From: [NEWMAN Emma](#)
To: [REDACTED]
Subject: RE: Meeting re: SUB TSP Public Comment
Date: Wednesday, February 14, 2018 6:41:44 PM
Attachments: [2018_02_13 SUB Supplemental Comments on Trans Plan.pdf](#)
[image002.png](#)
[image003.png](#)
[image004.png](#)
[image005.png](#)
[image006.png](#)

Emma Newman, Transportation Planner
City of Springfield
225 5th Street
Springfield, OR 79477
Re: Springfield Oregon Transportation System Plan

Springfield Utility Board is providing these comments to supplement its January 22, 2018 comments on the City's proposed Transportation System Plan update.

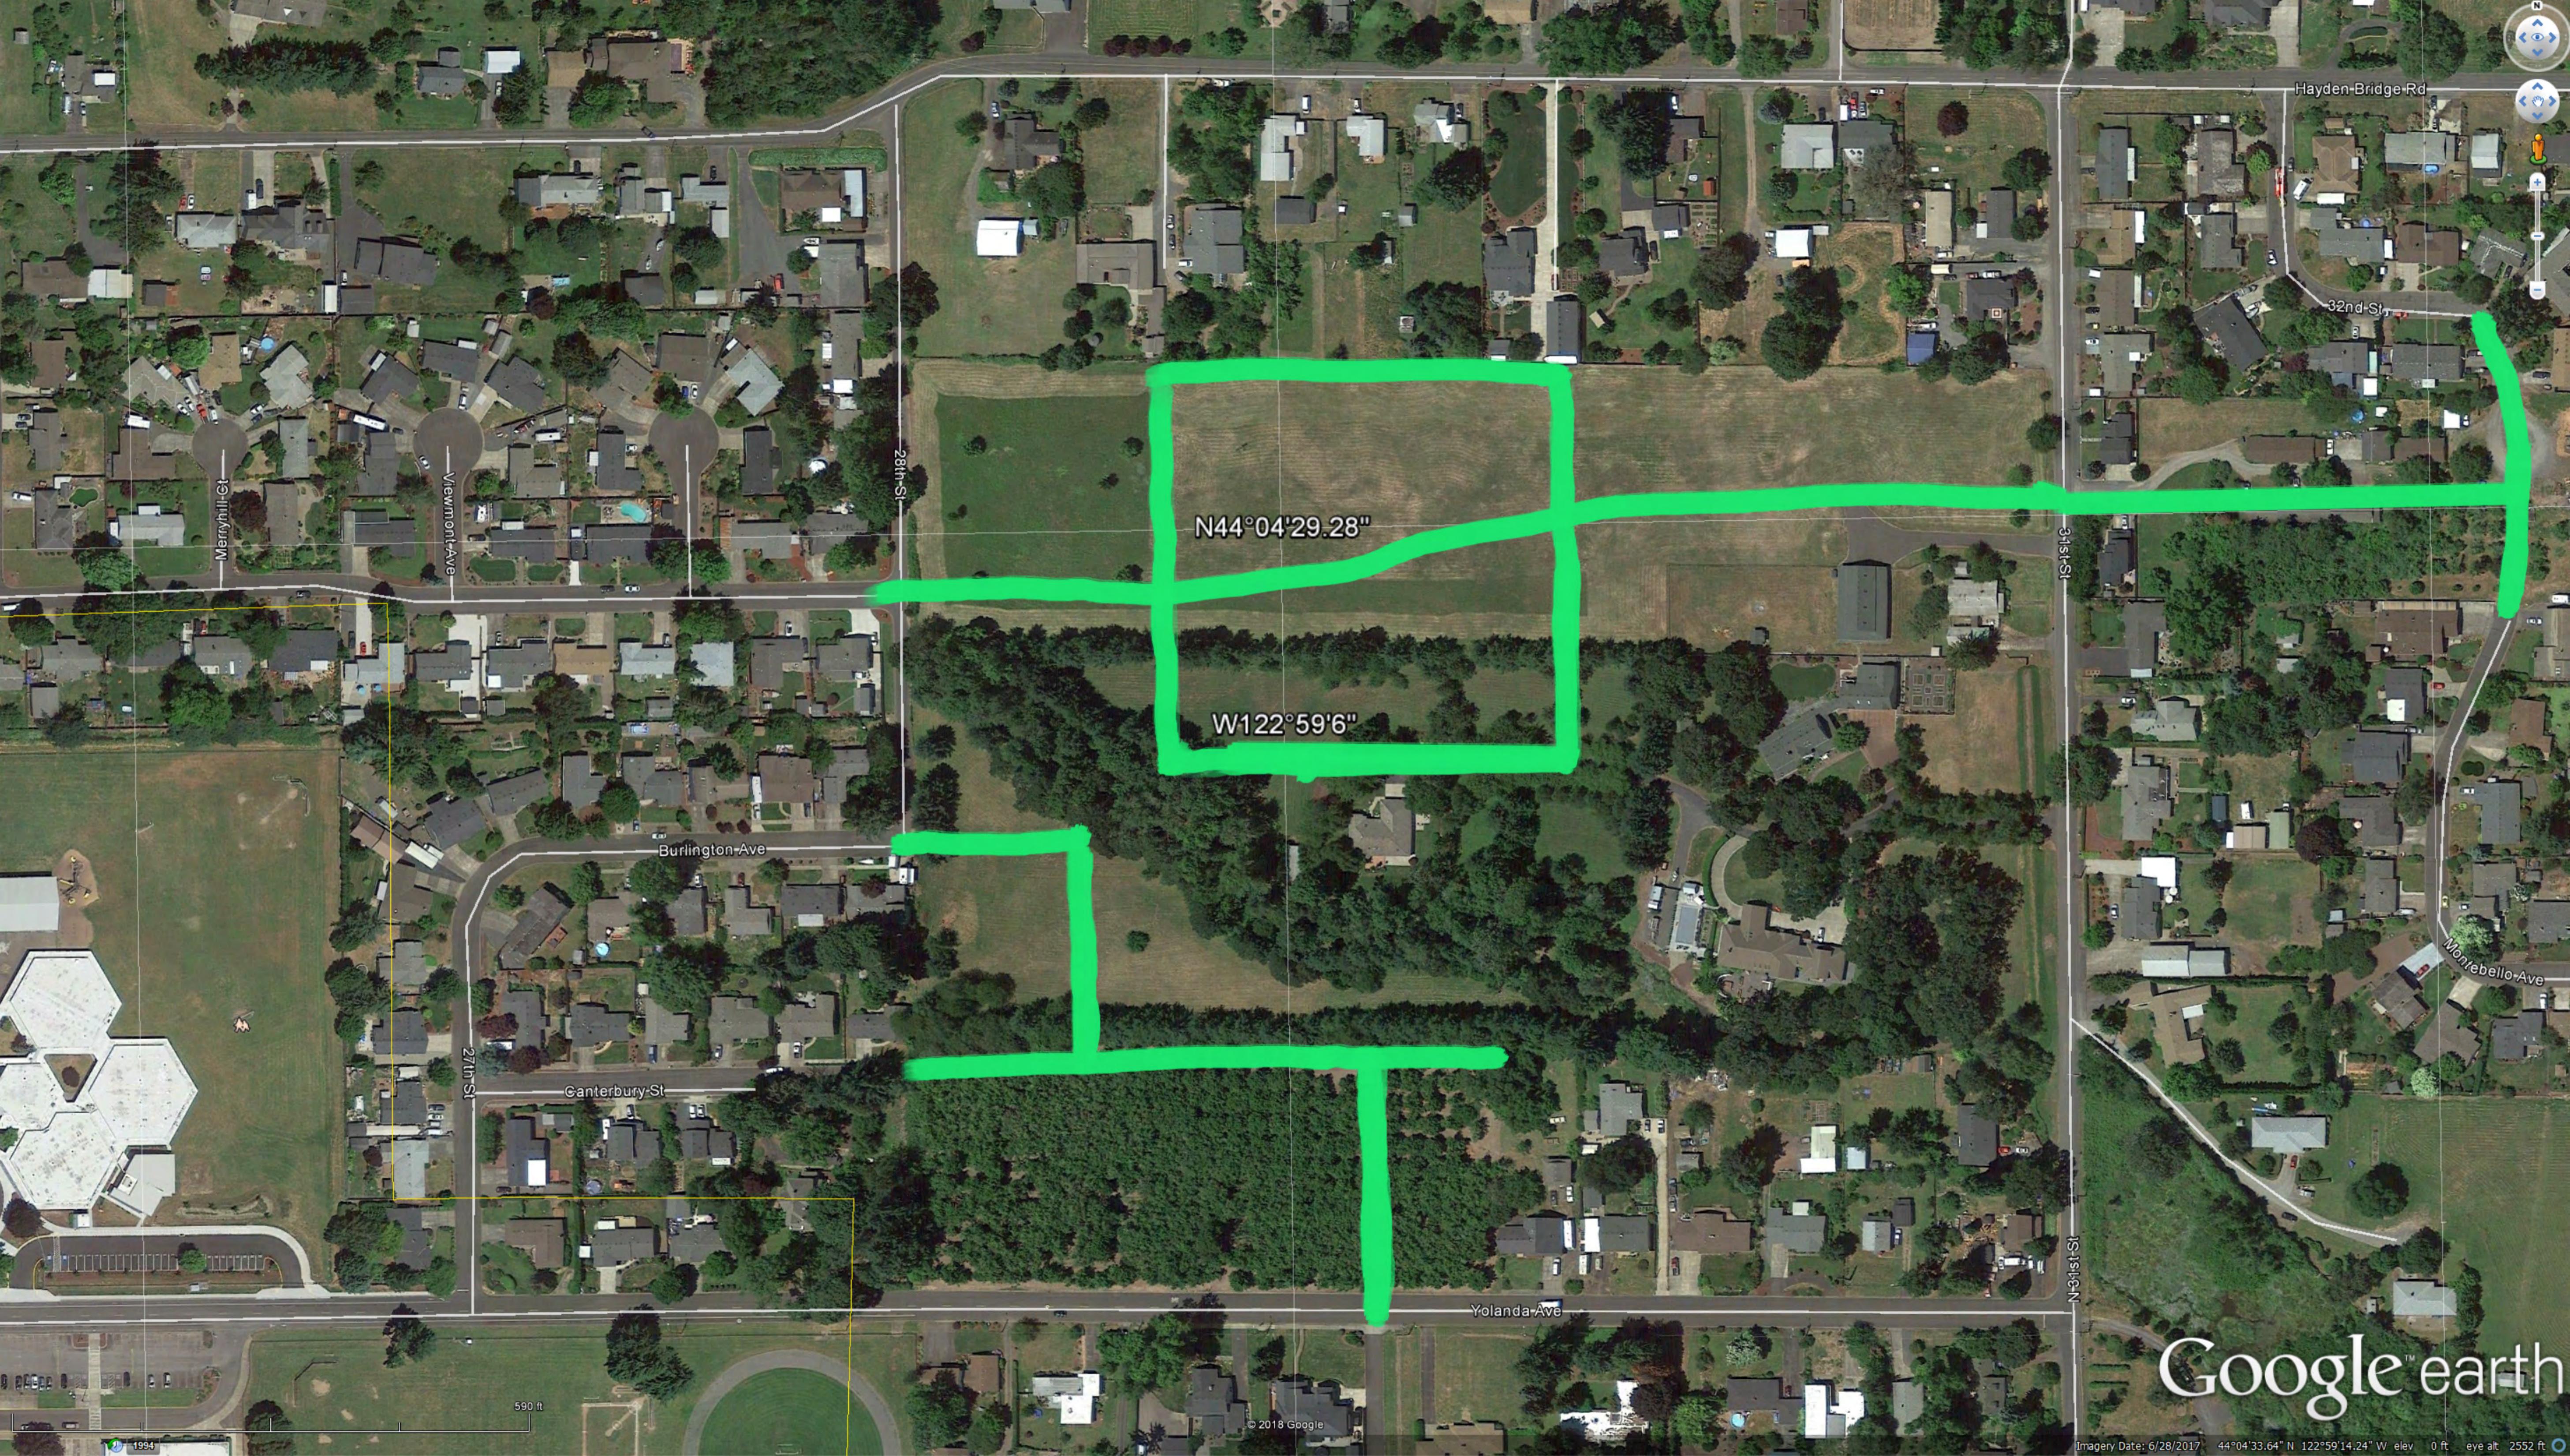
Thanks for meeting with me on Friday. Attached is pdf file showing a possible street plan that could work for my neighborhood and not effect the wetland area.

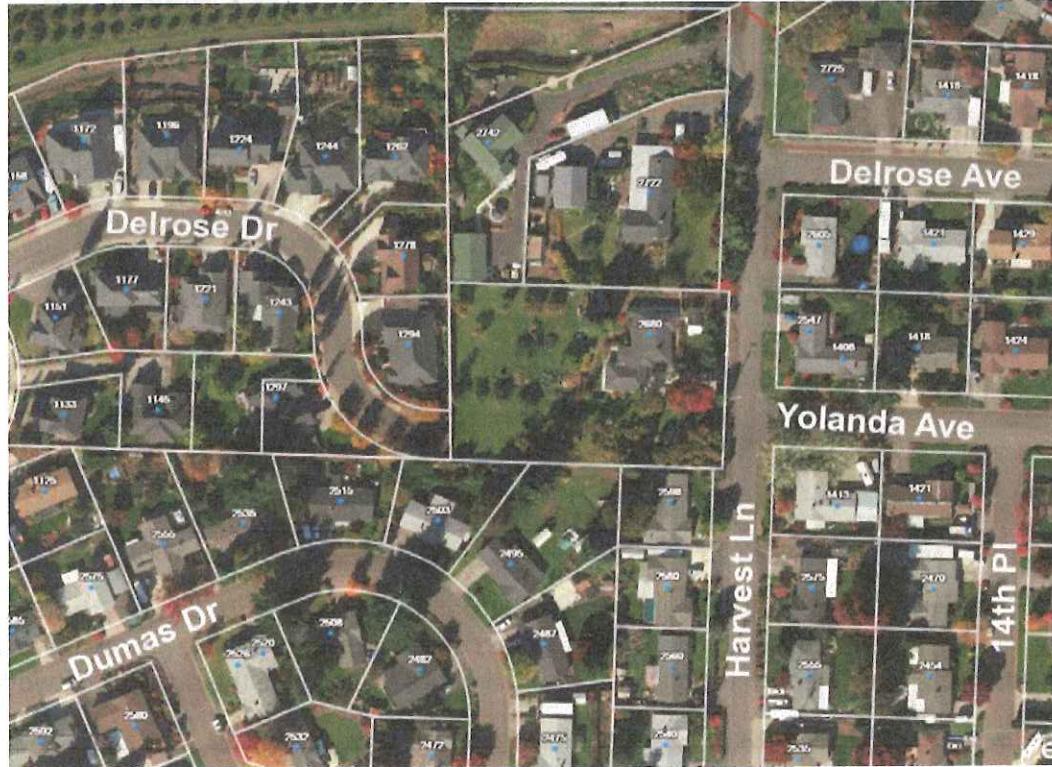
Additionally, as explained previously, Delrose Drive is a narrow local street with two blind curves, one at each end. Through traffic from Yolanda Avenue and Harvest Lane would create unsafe traffic conditions.

For these reasons, please vote to remove the Delrose Drive Local Street connection to Yolanda Avenue from the Conceptual Street Map before approving it and sending it on to the Springfield City Council and Lane County Commissioners.

Delrose Drive

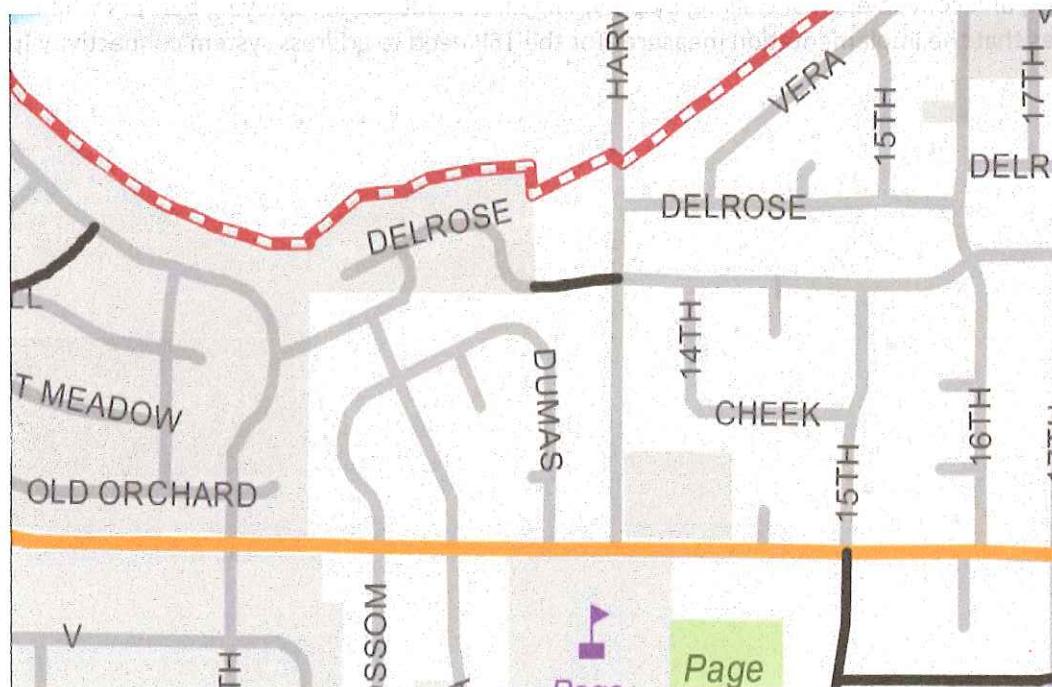
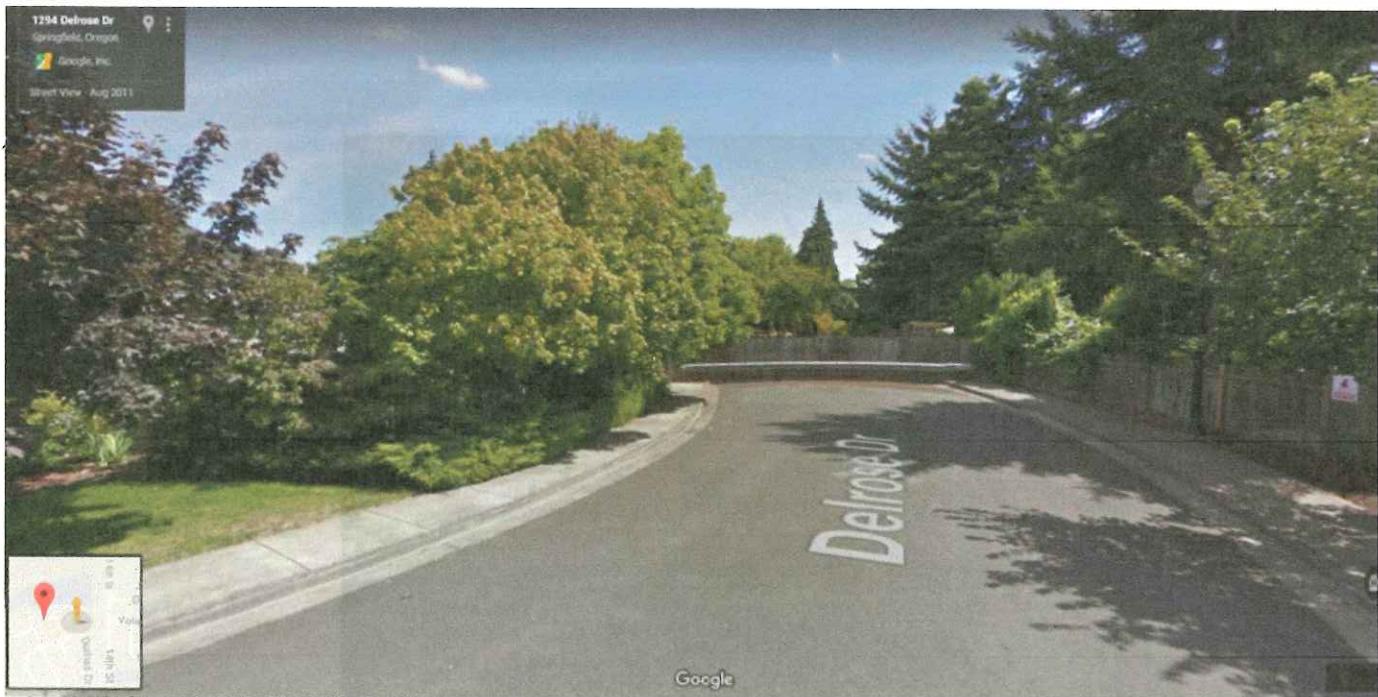
2680 Harvest Ln house is not located in alignment with the logical extension of right-of-way.

Delrose Dr is too long without a turnaround to meet current dead-end street standards. The Delrose Dr dead-end was built without a turnaround, which would have been required if this were a planned dead-end street. No sidewalk connects at the current end of the street, anticipating a connection to Yolanda Ave in the future to complete the sidewalk network.

The Delrose Dr to Yolanda Ave street connection would support TSP Policy 3.4 which states, "Provide for a continuous transportation network with reasonable direct travel routes to destination points for all modes of travel."

Additionally, TSP Policy 3.7 states, "Provide for pedestrian environment that supports adjacent land uses and is designed to enhance the safety, comfort, and convenience of walking by providing direct routes and removing barriers when possible." TSP Chapter 7 states that the implementation measures for the TSP need to address system connectivity (page 83, Springfield 2035 TSP).
